Model: Iris/Lilac (Controller Interface Type E)	Date: 15-Nov-99	No.: RA258014a
---	-----------------	----------------

RTB Correction

Subject: SC326 / Abnormal Image		Prepared by: T. Itoh	
From: Technical Service Dept., GTS Division			
Classification:	<input checked="" type="checkbox"/> Troubleshooting	<input type="checkbox"/> Part information	<input type="checkbox"/> Action required
	<input type="checkbox"/> Mechanical	<input type="checkbox"/> Electrical	<input type="checkbox"/> Service manual revision
	<input type="checkbox"/> Paper path	<input type="checkbox"/> Transmit/receive	<input type="checkbox"/> Retrofit information
	<input type="checkbox"/> Other ()

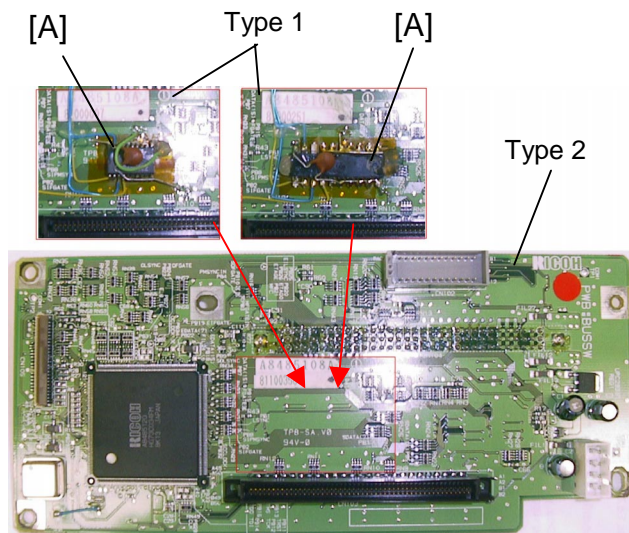
As shown in the picture, there are two types of BUSSW board (P/N #A8485108). Type 1 is the board on which an IC [A] has been manually soldered. Type 2 contains an IC18 soldered onto the circuit pattern by machine.

Type 1 is the board that was modified in the production (from #A8485105). This board contains one of the two ICs as shown in the picture to the right [A]. The only difference is in the size.

The function of the additional IC and IC18 is exactly the same. IC18 is soldered onto the reverse side of the Type 2 board.

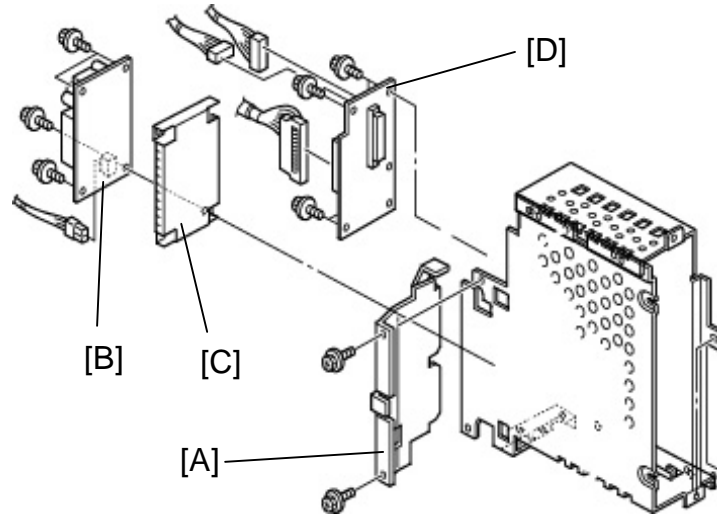
[1] Troubleshoot as shown below when the problem is reported.

NOTE: If the problem is related to IC18, the replaced (old) PCB can be re-used after cutting pins #12 - 17. (If the PCB is Type 1, it is not repairable and therefore not re-usable.) If occurrences still continue after cutting the pins, the problem is being caused by another PCB component.

NOTE: If the BUSSW board (IC18) causes the problem and the part is not available, cutting the pins (#12 - 17) of IC18 as explained section [2] on page [6](#) of this RTB solves the problem. (If the PCB is Type 1, the procedure on page 6 is not applicable.)

- BUSSW Board Replacement Procedure -

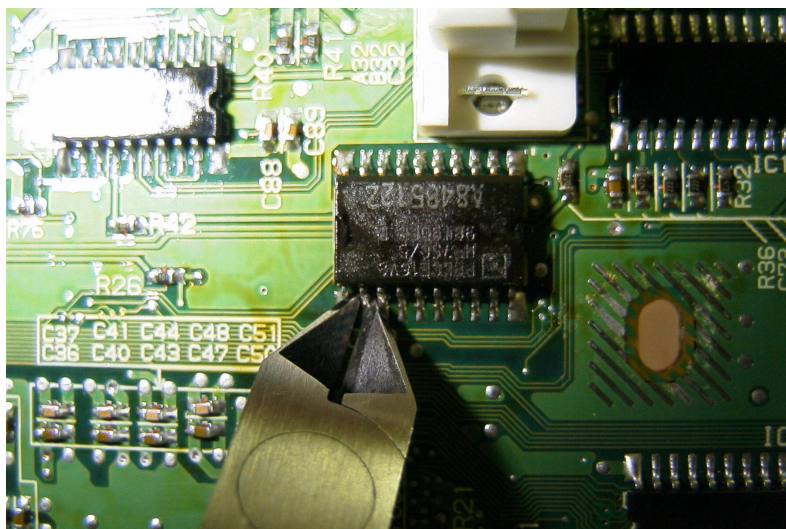
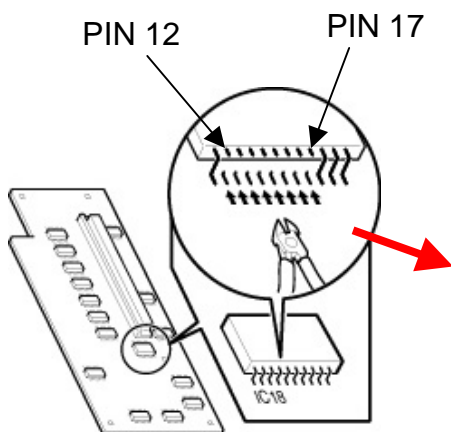
1. Turn off the main switch and unplug the power cord.
2. Disconnect the cable(s) from the controller.
3. Remove the exterior covers (used toner cover and I/F unit cover).
4. Remove the controller from the I/F unit (6 screws).
5. Remove the cover plate [A] (2 screws).
6. Remove the AC drive board [B] (4 screws and 2 connectors).
7. Remove the shielding plate [C].
8. Replace the BUSSW board [D] (4 screws, 1 grounding screw, and 2 connectors).

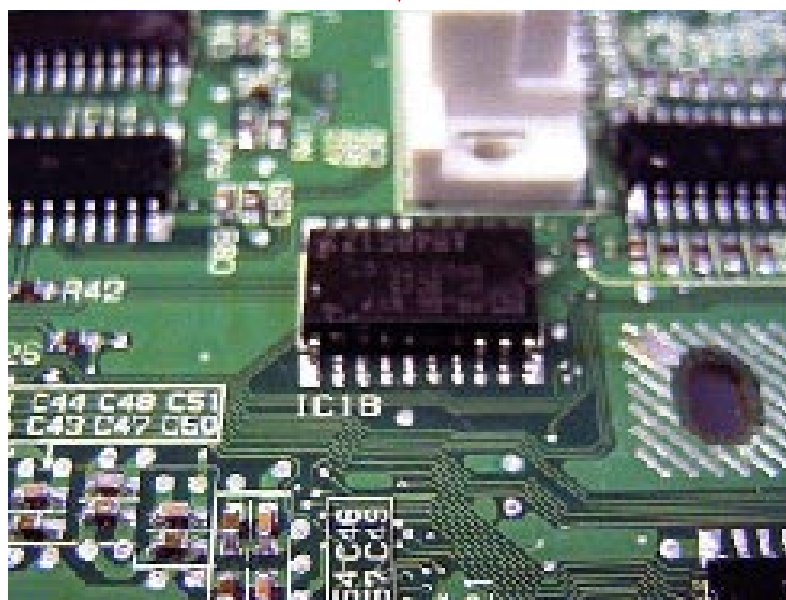
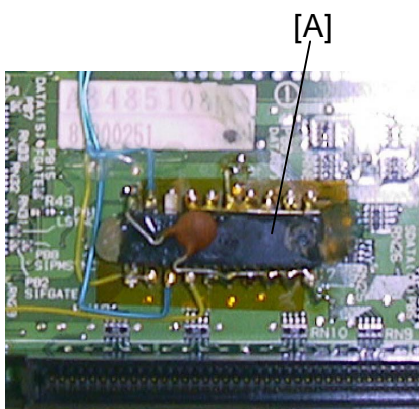
If the BUSSW board contains an IC [A], that has been manually soldered on, the procedure described below is not applicable. The BUSSW board would need to be replaced with #A8485112 when the problem occurs.

1. Remove the BUSSW board by following the procedure described on the previous page.
2. Using small cutting pliers, cut pins #12 to 17 so that they do not touch other pins or patterns. This will prevent a short circuit.
3. Remove the cut pins from the board surface.

NOTE: Be careful not to damage the PCB pattern or cut other pins. If pins #11 or 18 are cut, this will cause SC326.
